## NON MATERIAL AMENDMENTS REPORT

#### **UNCOMMON HOLBORN** 81 - 87 High Holborn London WC1V 6NU

astudio
ĒF	UCH-AST-XX-XX-PP-A-011005
	06th of September 2022
	P01
F	2020/1350/P (as amended)

#### 01.00 PROPOSED AMENDMENTS OVERVIEW 01.01 SE AXONOMETRIC VIEW

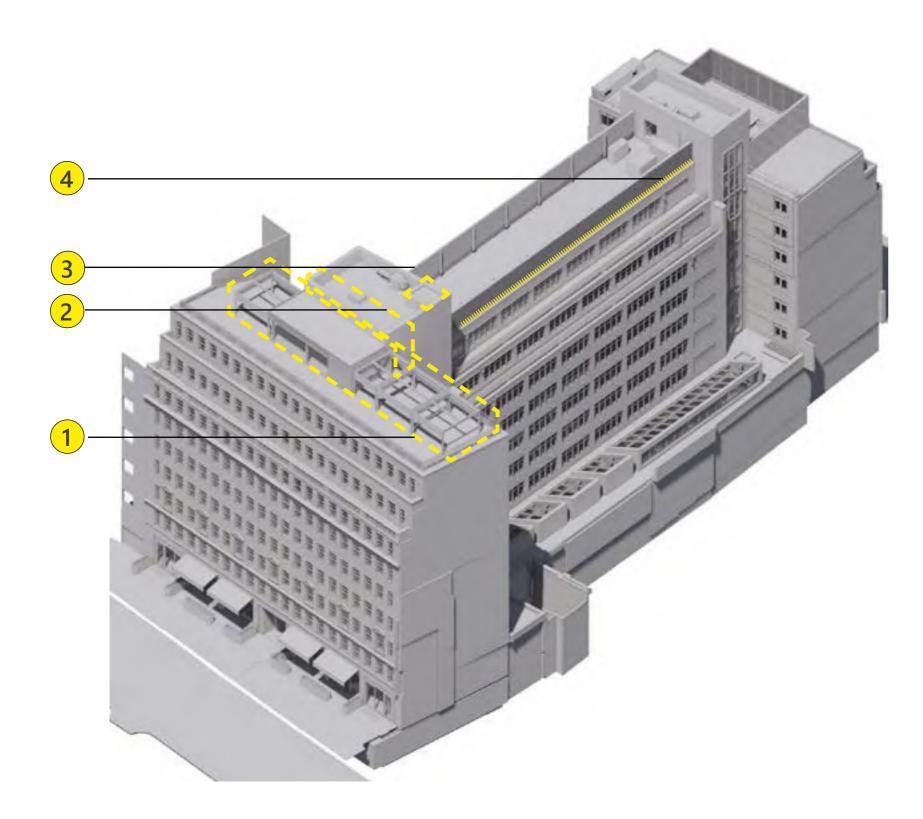
Item	Арр	Zone	Description
1	A	High Holborn Roof	<ul> <li>Covered area to be extended through a lightweight pergola structure as previously consented</li> </ul>
2	A	High Holborn Core	<ul> <li>Louvres added to the side walls of the core extension</li> </ul>
3	A	High Holborn Core	Lift overrun location
4	A	Link Block Roof	<ul> <li>Parapet extension due to increased roof build up</li> </ul>

#### 01.00 PROPOSED AMENDMENTS OVERVIEW 01.03 NW AXONOMETRIC VIEW

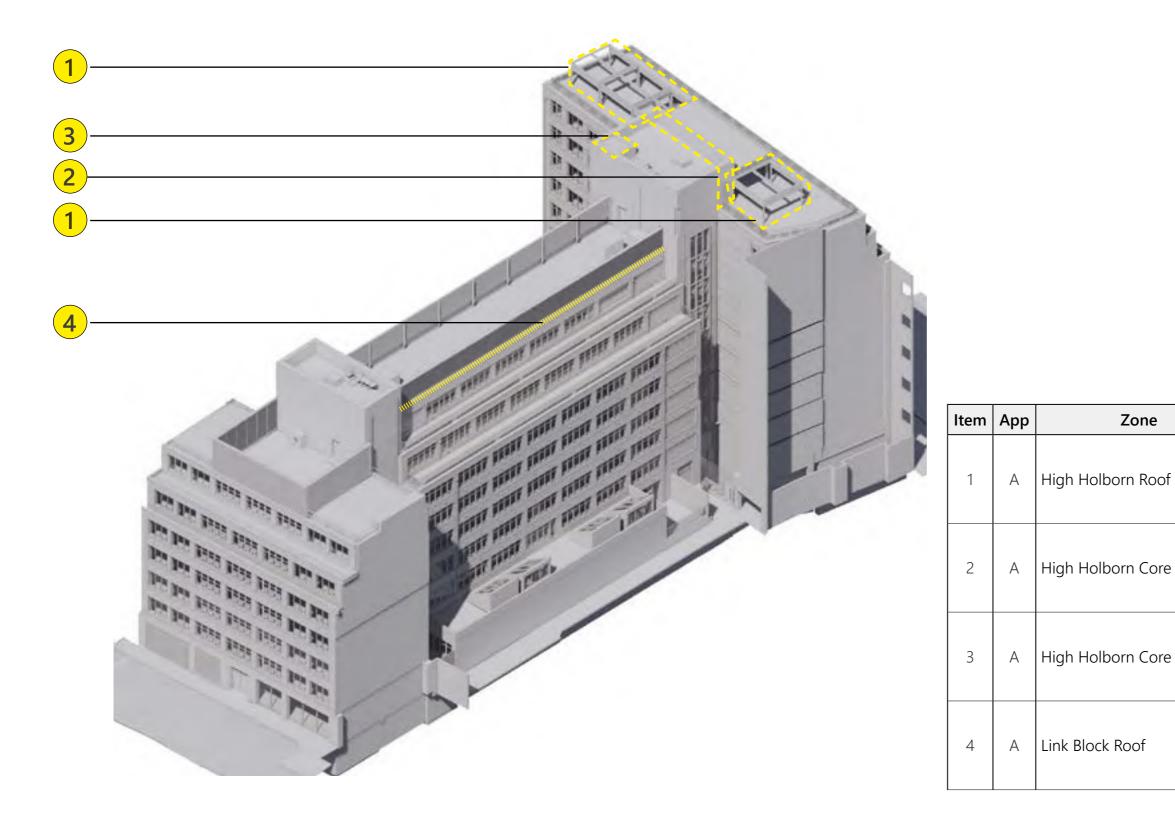
Description
Description
<ul> <li>Covered area to be extended through a lightweight pergola structure as previously consented</li> </ul>
<ul> <li>Louvres added to the side walls of the core extension</li> </ul>
Lift overun location
<ul> <li>Parapet extension due to increased roof build up</li> </ul>

#### 01.00 PROPOSED AMENDMENTS OVERVIEW 01.01 HIGH HOLBORN ROOF TERRACE

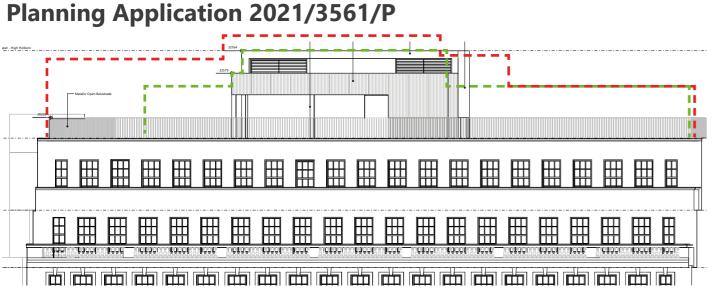
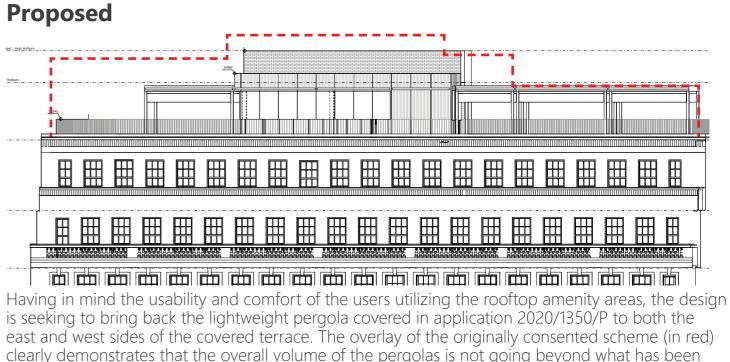
The main amendment to application A - Roof plants and extensions - is to seek approval for a lightweight pergola structure on the High Holborn roof, as previously consented in 2020 (2020/1350/P). This reverts back the amendments sought in 2021 (2021/3561/P), which have omitted the pergola from the design.

Planning application for a 1.5 storey high roof extension including plant area to the west, covered terrace in the middle and a lightweight pergola too the east. Drawing above shows overlay of the 2021 amendments (in blue) and proposed amendment (in green).

The amendments sought in 2021 reduced the roof extension: the lightweight pergola was omitted and the plant relocated to the link block. The drawing above shows the overlay of the originally consented scheme (in red) and proposed amendment (in green).

#### 02.00 CONSENTED VS. PROPOSED DRAWINGS 02.01 7TH FLOOR PLAN

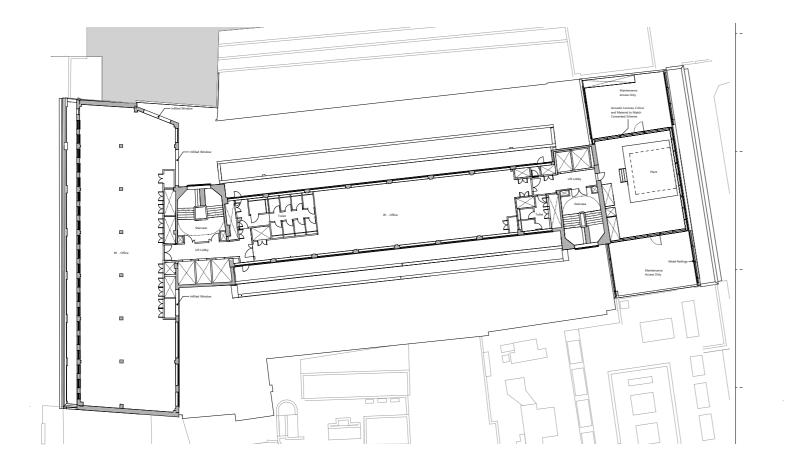
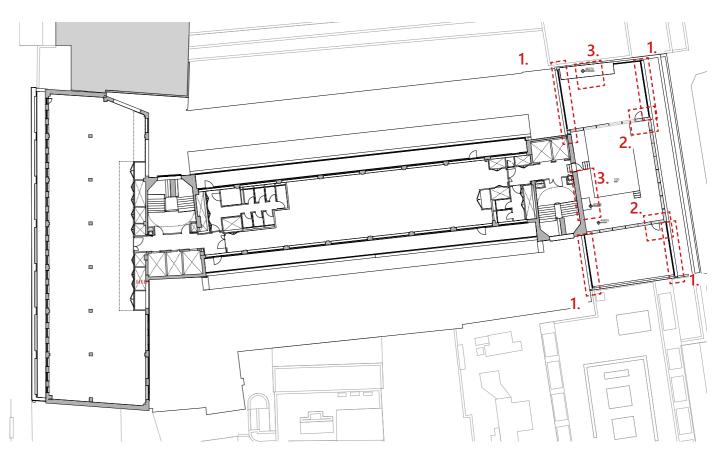
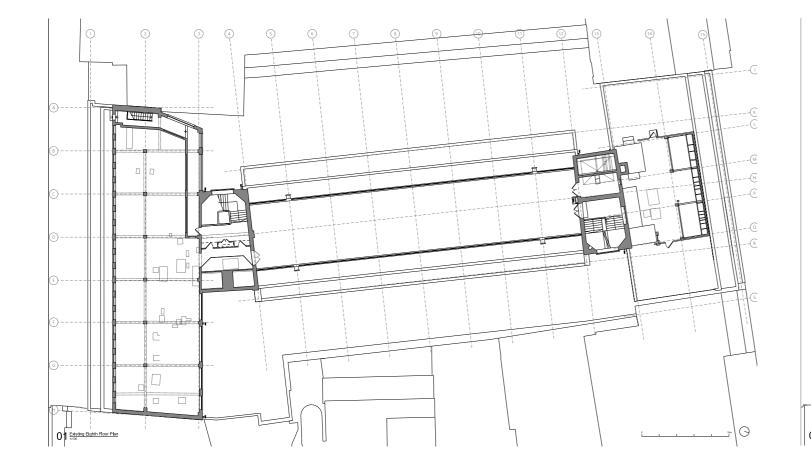
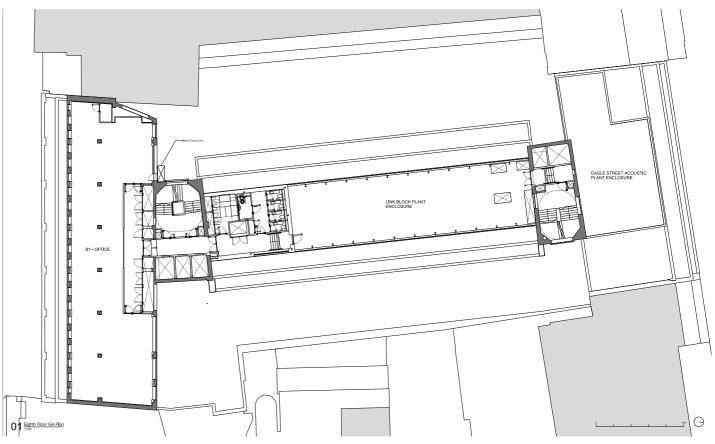
- 1. Metal railings to replace existing ones
- 2. Position of door within louvred screen amended
- 3. Riser up stands configuration amended and height clarified

#### 02.00 CONSENTED VS. PROPOSED DRAWINGS 02.02 8TH FLOOR PLAN

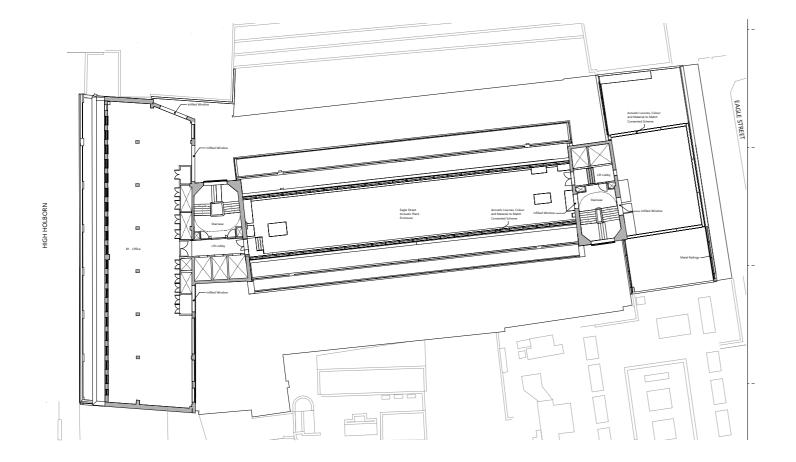
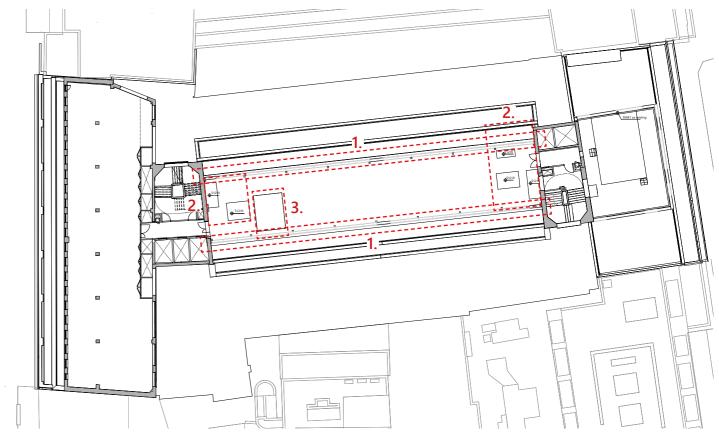
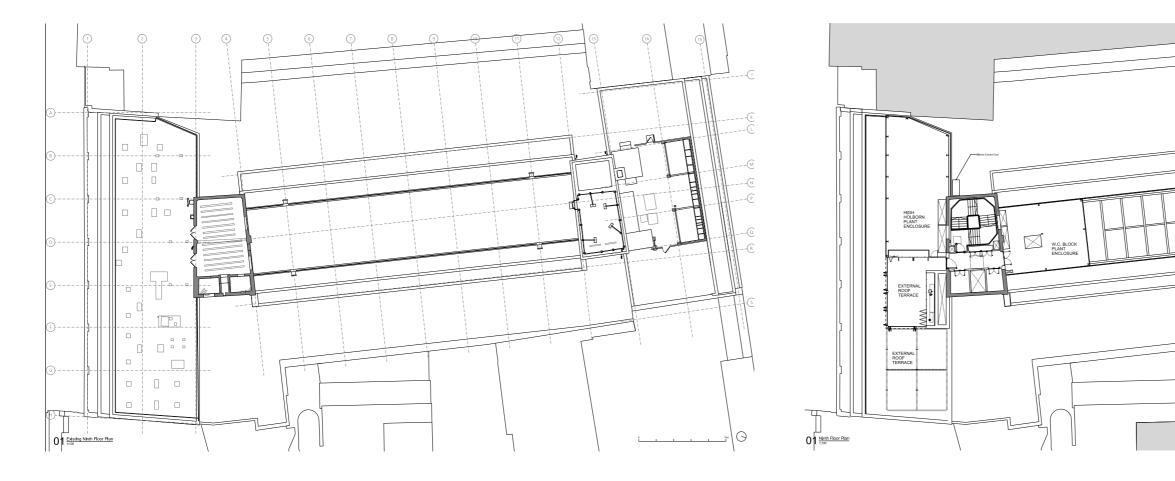
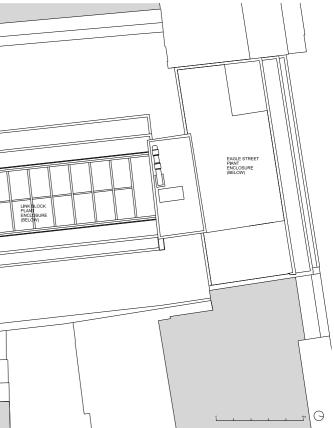
- 1. Parapet of link block roof extended to accommodate overall roof build up (strengthening of existing slab and insulation for improved thermal performance). Brick to match existing.
- Riser up stands configuration amended and height clarified.
   Weathering protection enclosure to plan equipment. To be concealed behind acoustic louvres.

#### **02.00 CONSENTED VS. PROPOSED DRAWINGS** 02.04 9TH FLOOR PLAN

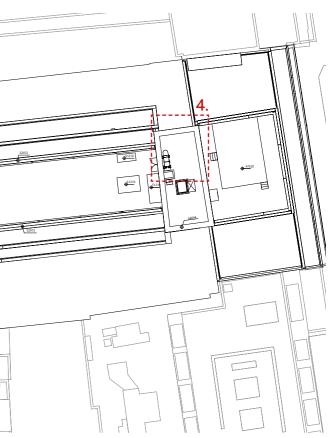
1. Covered area to be extended through a lightweight pergola structure as previously consented (2020/1350/P). Pergola structure to have a PPC finish, colour to match the metal cladding of the roof extension.

- 2. Louvres required on the side walls of the new brick walls of the previously consented roof extension.
- 3. Folding screens to be glazed.

4. Existing lift overrun up stand omitted. Infill slab proposed.

#### 02.00 CONSENTED VS. PROPOSED DRAWINGS 02.05 ROOF PLAN

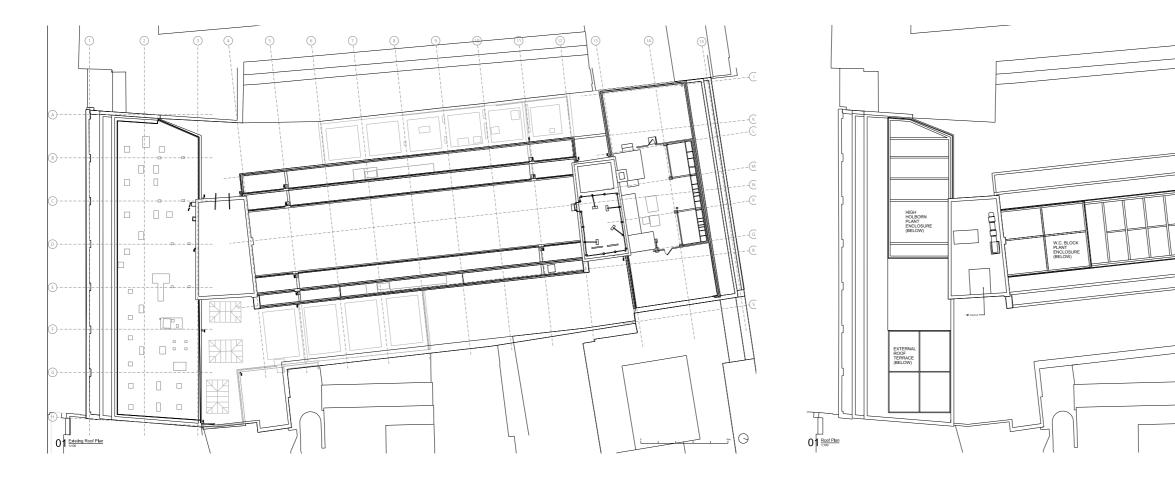
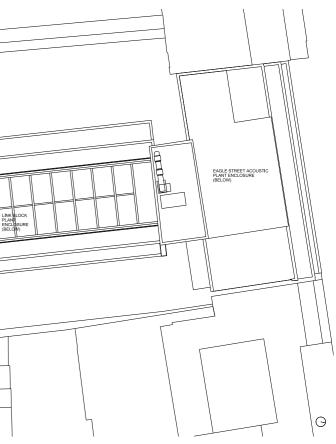
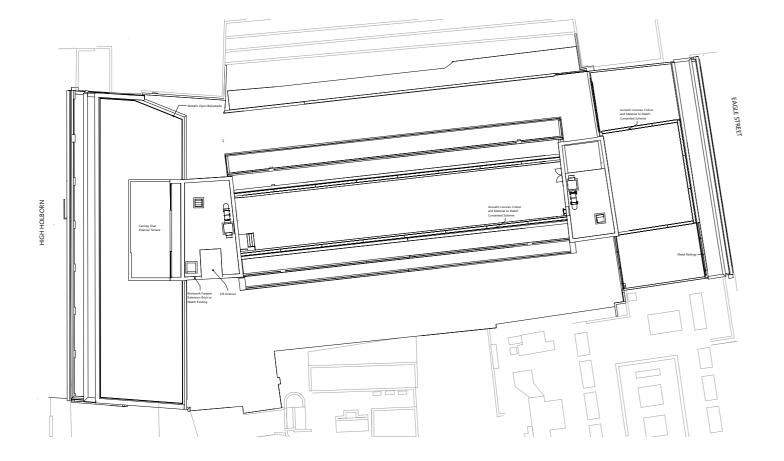
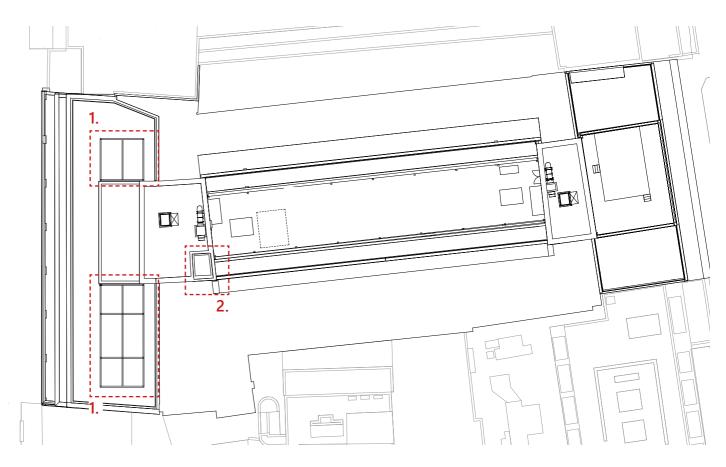
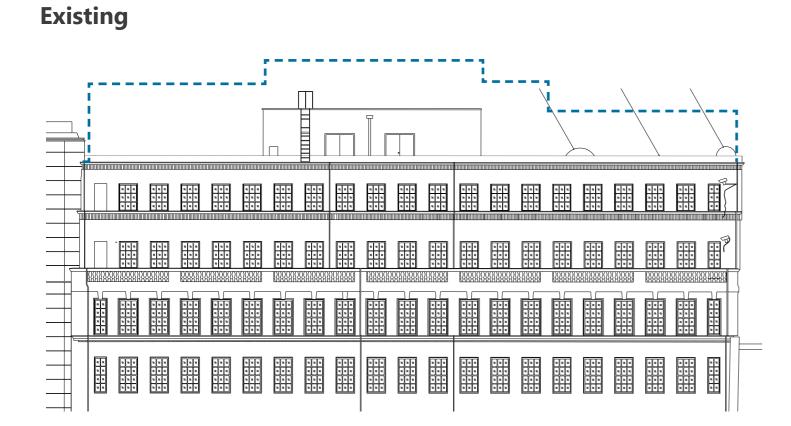
- 1. Covered area to be extended through a lightweight pergola structure as previously consented (2020/1350/P). Pergola structure to have a PPC finish, colour to match the metal cladding of the roof extension.
- 2. Location of lift overrun amended.

#### **02.00 CONSENTED VS. PROPOSED DRAWINGS** 02.06 (SOUTH) HIGH HOLBORN ELEVATION

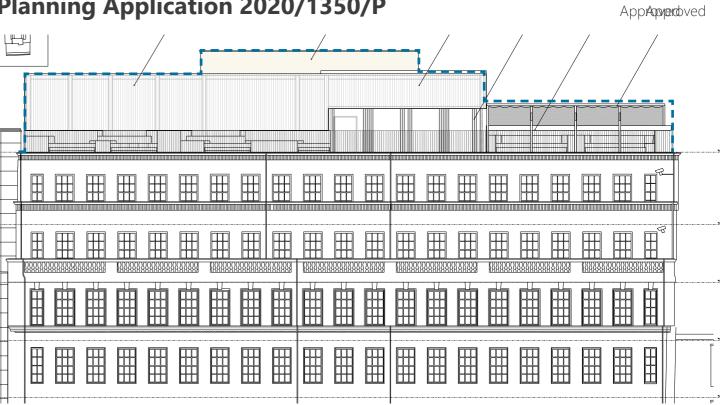
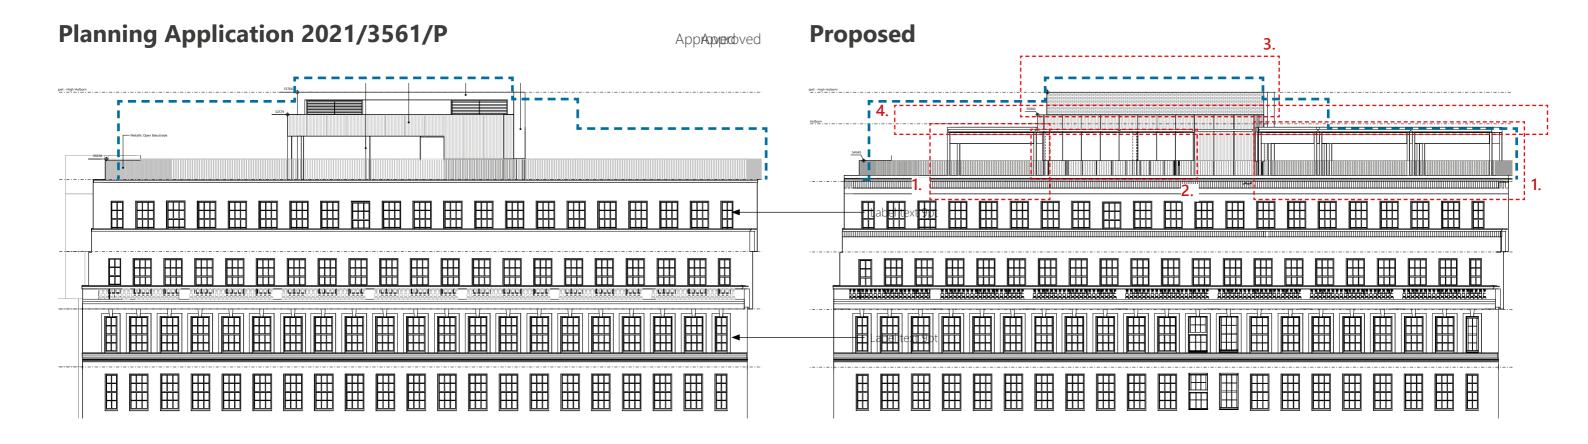
- 1. Covered area to be extended through a lightweight pergola structure as previously consented (2020/1350/P). Pergola structure to have a PPC finish, colour to match the metal cladding of the roof extension.
- 2. Folding screens to be glazed.
- 3. Louvres omitted from south elevation. Louvres moved to side walls of brick wall extension (refer to 9th floor plan amendments)
- 4. Retractable awnings proposed to the whole extent of the covered terrace, including pergolas.
